PROJECT
Dendrons

QUESTIONS FOR THE ENGINEER

Structural queries on the ICF approval drawings - sheet 1 of 4

UKPCS-003-EQ-01

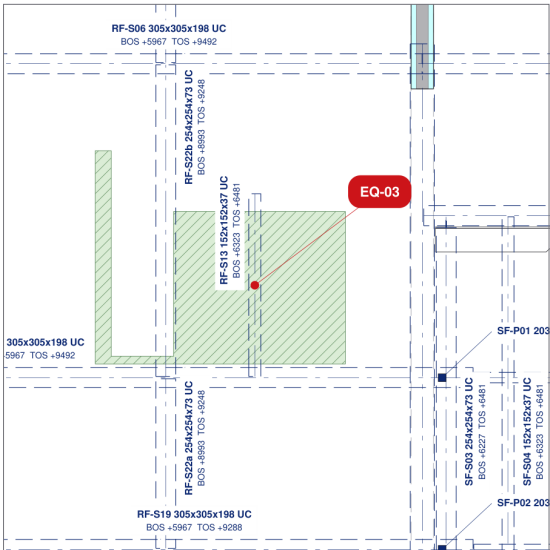
S-101 shows the stair void as the ellipse only (x 6.5-.12.4 m, y 2.2-.6.2 m) with a UC 203x203x46 trimmer on its north tangent (y -6.23 m, TOS 171.950, "WALL BELOW") and hollowcore north of it. The architect's two curved flights (19 risers each) continue north beside a 3.3 m slot and land on the first floor at y -8.9 m; that trimmer and the planks north of y 6.23 m would sit 1.1-1.5 m above the treads.

Please confirm the extent of the first-floor void (model: ellipse + flights + slot to y 8.93 m, planks HC-032/033/034 omitted, landing edge on the plank at y 8.89 m) and the trimmer arrangement around it.

EQ-03 RF-S13 lifting beam (UC 152x152x30) over the lift shaft - level and bearing

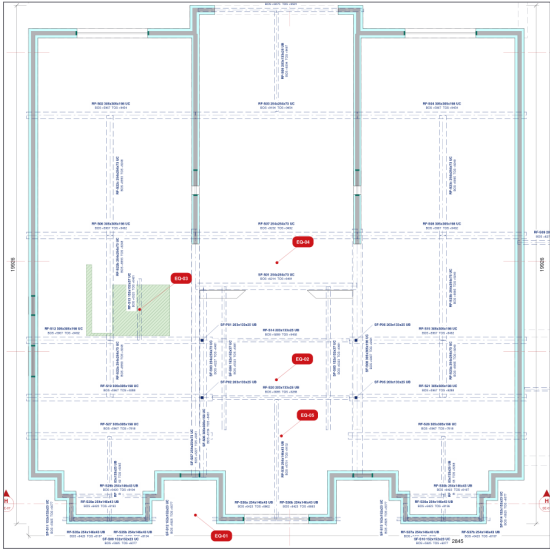
ISSUE S-103 marks RF-S13 (UC 152x152x30, x 4225, y 7030..9373) as the LIFTING BEAM over the lift shaft; S-100 shows the shaft with UC 203x203x46 trimmers (2005 x 1925), S-101/S-102 the LIFT VOID and the STAIR VOID beside it, S-205 the blockwork shaft walls and the 200 pit recess. The model carries the blockwork shaft (walls x 3185..3385 / 5185..5385, y 7191..9145, 200 W/E, 100 N/S) and the secondary-stair enclosure west of it (x 2181..2385, to y 9925) from the architect's plans, up to the underside of the roof plateau steel (178.240 TOS). RF-S13 is modelled at TOS 175.229 (the second-floor level) bearing on the shaft's N and S walls.

QUESTION Please confirm the TOS of the lifting beam (175.229 as modelled, or at the roof plateau), its bearings on the blockwork shaft walls, the shaft wall thickness and the extent of the secondary stair (flight not modelled).

EQ-07 S-120 internal ICF walls flanking the hall (x 6.2 m / 12.4 m) - door positions

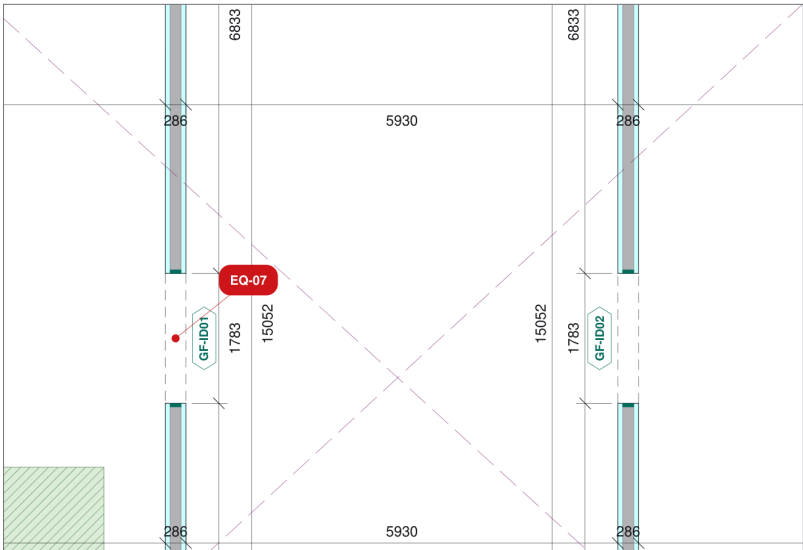
ISSUE S-120 shows ICF 286 mm walls either side of the hall with lintels at y 10.0-11.8 m and (S-121) 12.7-13.6 m; the model has these walls (Walls 43/44) with double doors GF-ID01/02 (1783 wide) and FF doors FF-ID01/02 (915) from the architect's swings. S-120 also shows lintels on the annex cross wall (Wall 46) at x 21.6-22.8, 23.5-24.5 and 26.9-27.8 m and on Wall 47 at y 5.05-6.87 m; the architect's plan shows the Wall 46 doors at 23.5-24.5 and 26.85-27.8 m and single doors at the north ends of Walls 45/47. Modelled to the architect (GF-ID03..07).

QUESTION Please confirm the door positions on the internal ICF walls.
